BATTLE OF INTERMITTENT WATER SUPPLY INSTRUCTIONS QUESTIONS & ANSWERS

This document will include the different comments received by the organisation and the corresponding responses.

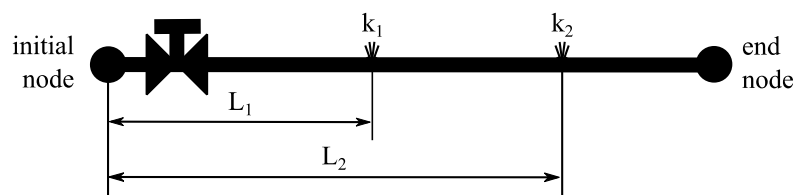
Q2. The evaluation is going to be performed based on the .INPs provided by the applicants. In the section "All participants will be verified to comply with the following restrictions:" It is not stated that any modification not stated in the template is not approved, eg.: actually deleting parts of the network. It would be clearer to generate the INP's and perform the evaluation directly from the excel template, rather than leaving parts up to the applicants.

The INP files submitted by the participants will allow to analyse how each of them has modelled the leakage and consumption in the network. However, the evaluation of the solutions will be based on the investments and control actions defined in the corresponding Excel files.

Only network modifications defined in the template may be included in the INP files. No network modifications that have not been defined in the INP file should be made. Specifically, pipes may not be deleted. Any pipes to be shut off must be shut off by the installation of the appropriate isolation valve.

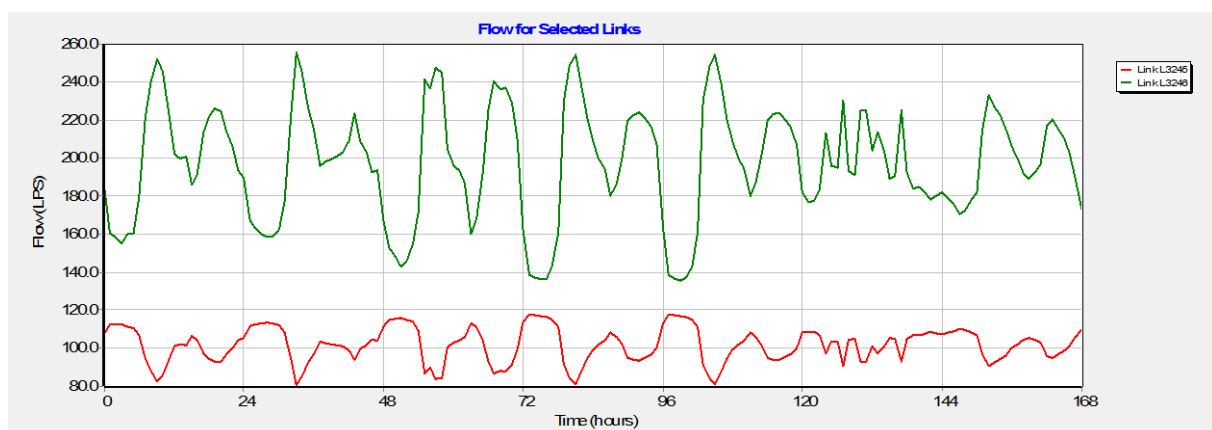
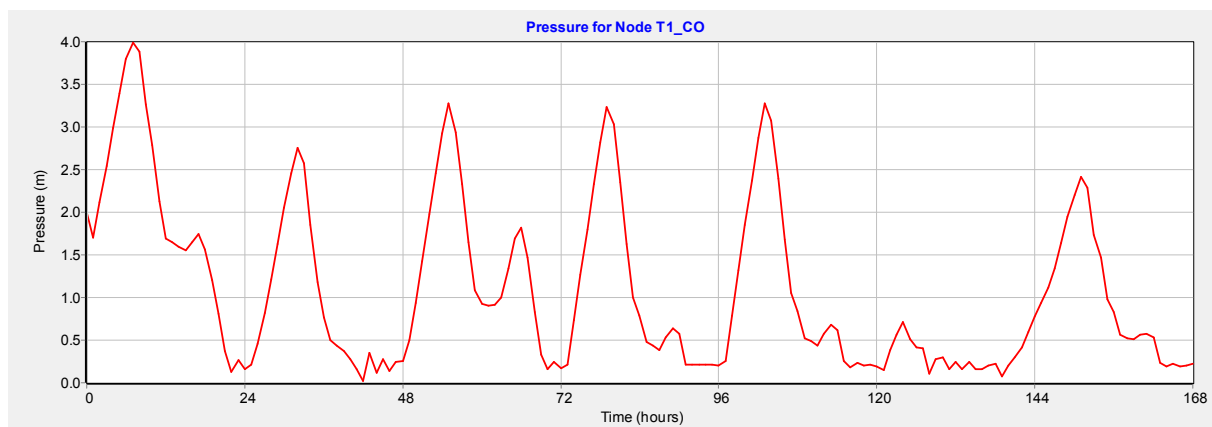
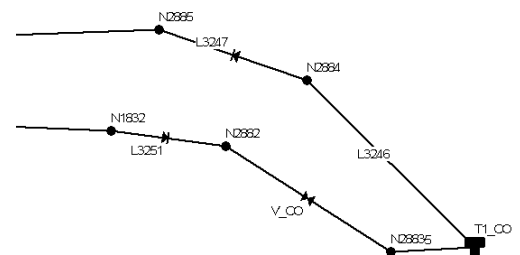
Q8. Are the isolation valves those indicated as TCVs in EPANET? In the EPANET model, there are some closed pipes. Are they other isolation valves or what else? I then understand that isolation valves can be accounted for either by closing the pipe or by installing a TCV and closing it. The already present valves (PRV, FCV,PSV) can also be considered as isolation valves without extra cost. Finally, since TCVs are not included as regulation valves in the instructions, they cannot be purchased and installed for regulation purposes, based on their head loss setting.

There are not many valves installed in the network. The TCV valves of the EPANET model can be considered as isolation valves. Any other type of valve of the model (PRV, FCV, PSV) can also be considered as isolation valve if appropriate. Additionally, there are a number of initially closed pipes in the model. These pipelines are considered to have an isolation valve connected immediately adjacent to the initial node in the model (see question 3 of this document).

- Isolation Valves: are those that are in the model as closed lines. They are valves that can be completely open or completely closed. They cannot be used for regulation by introducing a pressure drop.
- Regulation Valves (TCV). These are manual regulating valves in which the loss coefficient can be defined. They can be used as isolation valves since they can be fully opened or closed.
- Automatic valves (PRV, PSV, FCV). They can be used as isolation valves as they can be fully opened or closed. Additionally they can function as control valves.

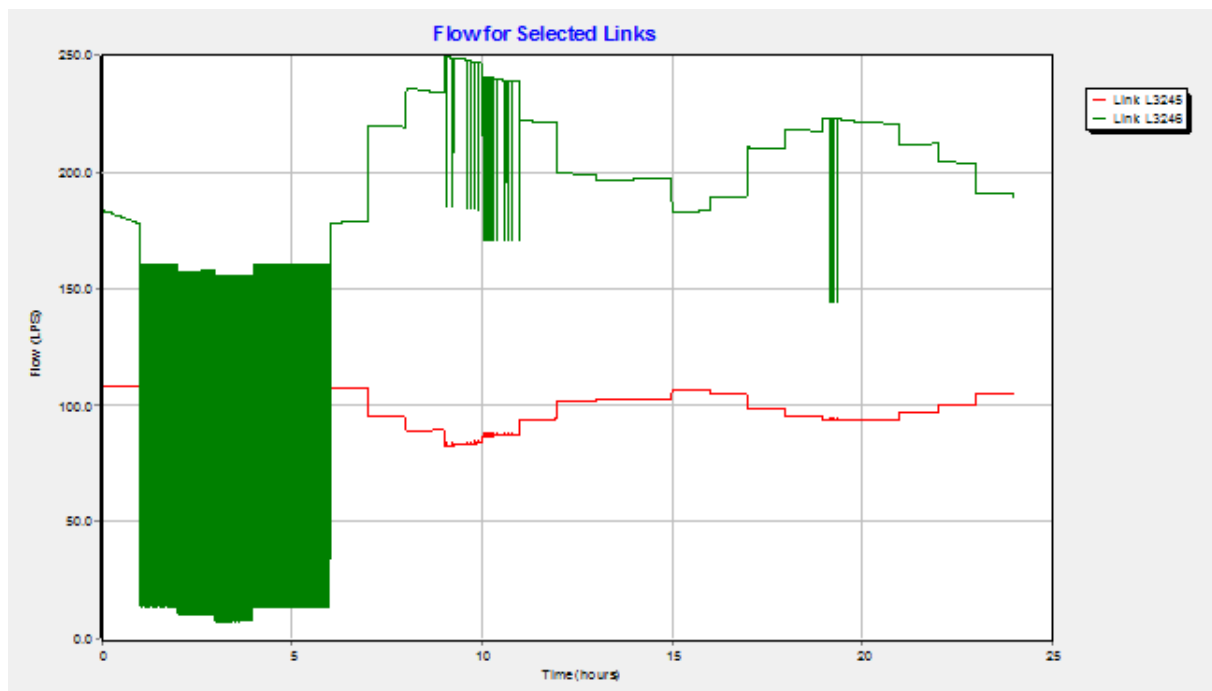
Q9. I have a question about tank T1_CO in the network BIWS.inp, before adding leakage and doing anything else. I ran the simulation as the file is. The output with the tank level is the one shown in the figure below. It seems weird that the outgoing water discharge is always larger than the incoming water discharge (see figure below). The water discharge patterns are not in agreement with the tank pattern. The problem is solved is the tank is replaced by a no-storage junction. Maybe, I am using EPANET 2.2 badly and I would apologize if this is the case. Please, can you help me with this?

Apparently, the tank outlet flow rate is at all times higher than the inlet flow rate. The explanation for this phenomenon is in the dynamic behavior of the tanks in EPANET. I believe there has been no change in this issue since version 2.0. That is, the problem occurs the same in version 2.0 as in version 2.2.

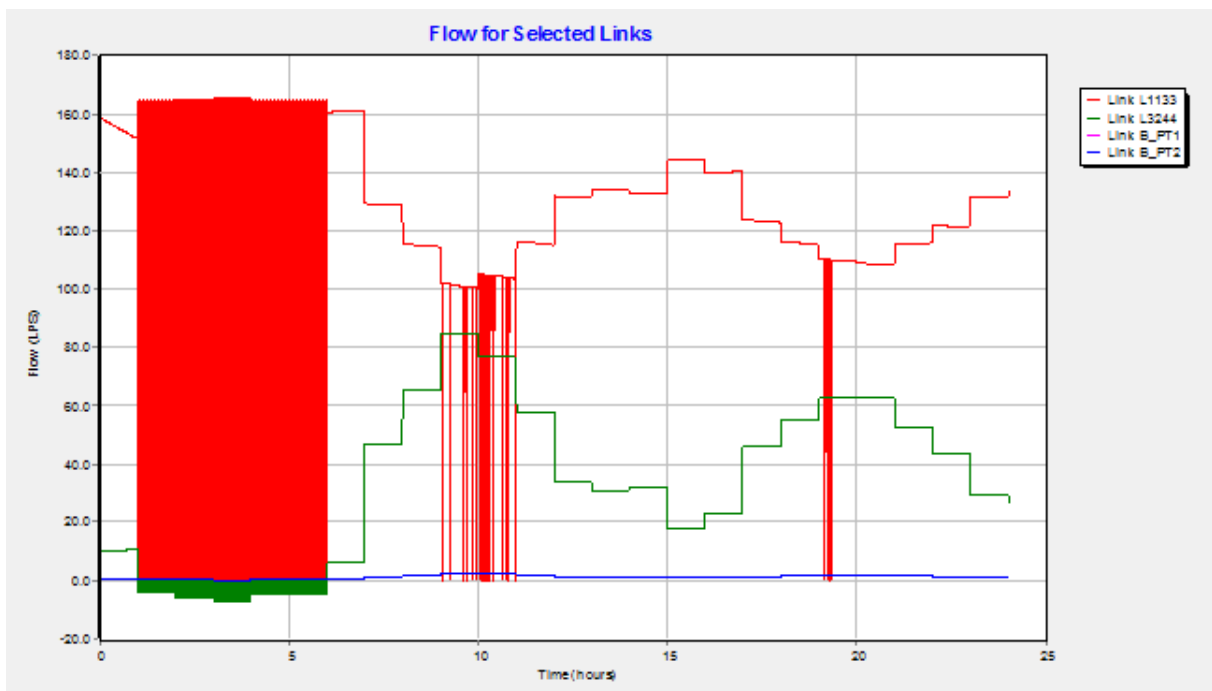
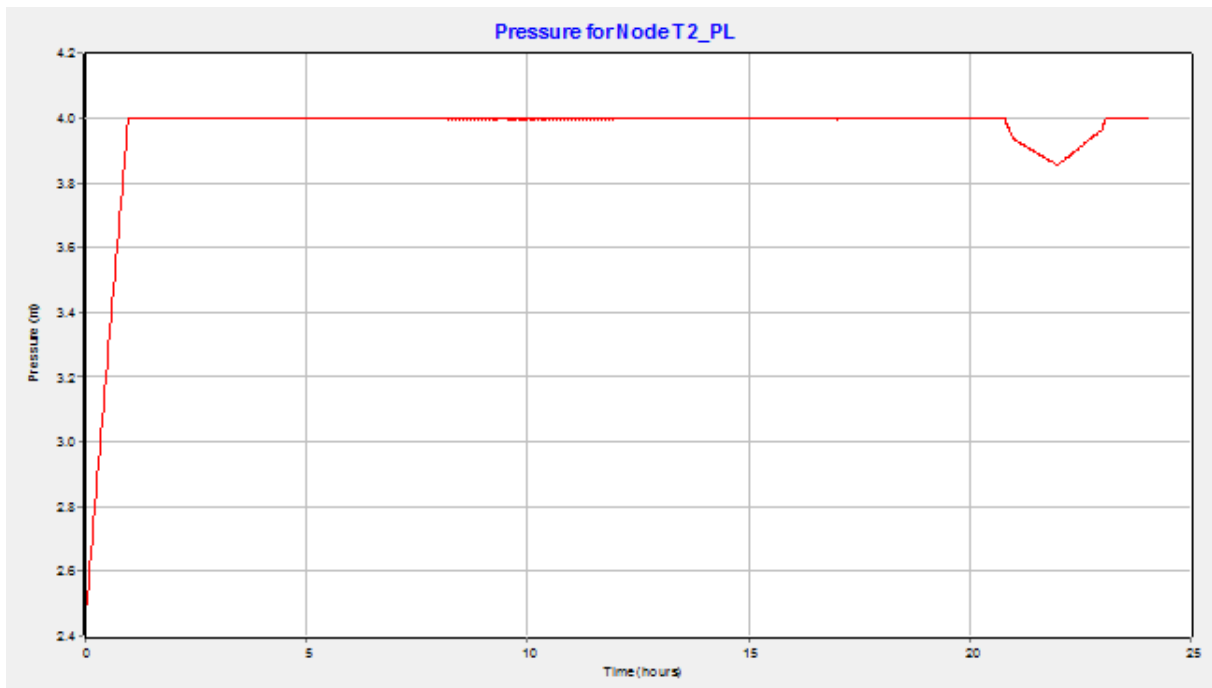
To explain it best we will analyze in detail the behavior of the system, either with the use of the Toolkit or with the use of a smaller hydraulic time step. If we analyze the behavior of tank T1_CO during the first 24 hours with a hydraulic time step of 20 seconds, the inlet and outlet flow rates of this tank are:

As can be seen, there are times when the inlet flow rate is higher than the outlet flow rate. Why is this behavior occurring in line L3246? Why are these variations occurring? The problem is not in tank T1_CO but in tank T2_PL. The level and flow rate graphs in this tank are as follows:

As can be seen, the T2_PL tank reaches its maximum level. This starts the EPANET automation to prevent the tank from overflowing. That is, it closes the inlet piping. However, when the inlet pipe is closed and there is still an outlet pipe from the tank, the level decreases slightly. This causes the inlet pipe to open again and water enters. Quickly the maximum level is reached again and the pipe closes again. This phenomenon becomes a continuous process of opening and closing the inlet pipe. It is a phenomenon that can only be observed if the analysis is performed with small hydraulic time steps or using the EPANET Toolkit. If the network is analyzed with hydraulic time step 1 hour this phenomenon is not observed and it seems that the inlet flow is always lower than the outlet flow.

The operation of the T2_PL tank causes the outflow of the T1_CO tank to be intermittent. That is the explanation that the outflow is not always higher than the inflow. When the T2_PL tank is open, flow comes out of T1_CO. However, when T2_PL is closed, hardly any flow comes out of T1_CO. If the volumetric balance is performed, the equation of continuity in the tank is fulfilled in all cases.

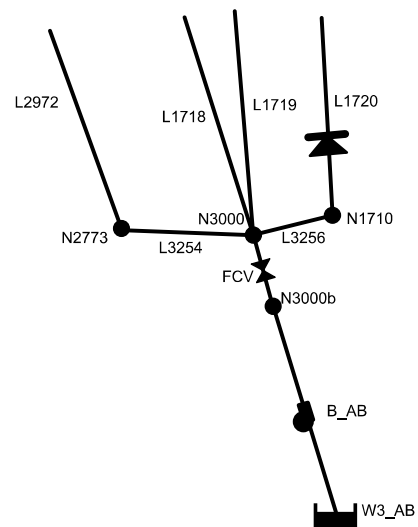
Q31. In section 3.4 of the instructions, it is stated that one of the alternatives for investments is replacing existing well's pumps. The network has 2 pumps which are not well's pumps but regular pumps adding pressure to the system - B_PT1 and B_PT2. Are these pumps also can be replaced although they are not well's pumps?

Paragraph 3.4 of the Instructions only referred to the alternative of replacing the existing well pumps. In the case of B_PT1 and B_PT2 they are not well pumps. They are pumps that are in a pumping station. For this reason we have added a comment on this in the update of the Instructions. Pumps B_PT1 and B_PT2 are not considered to be well pumps. They are considered to be in a pumping station. Therefore, only in this pumping station, pumps can be

installed in parallel with the existing ones. However, the range of available pumps is the same (Table 3 of the Instructions). The installation cost function of these pumps is the same.

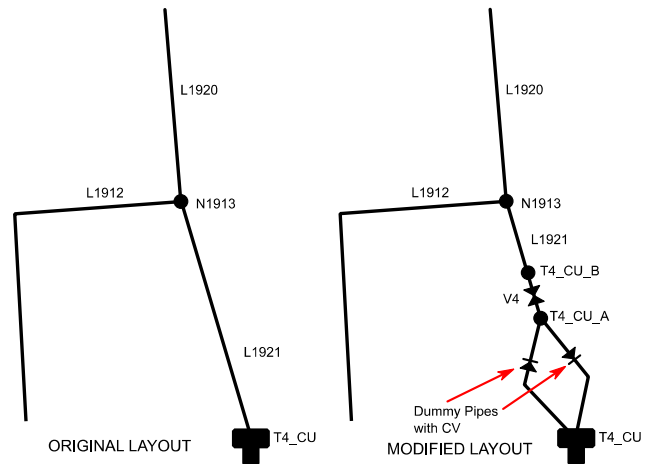
Q34. How do we consider pipelines where there is a check valve and leakages are defined? Lines L3247 and L3251 are CV (check valve) type. Where is the check valve considered to be installed with respect to the check valve?

The location of the check valve with respect to leakage is the same as the interpretation of the position of the isolation valves in the pipelines that were initially closed in the model (see Q3 of this document or section 3.3 of the update of the Instructions). It is assumed the check valve is next to the initial node of the pipeline. That is, leakage will always be downstream of the check valve.
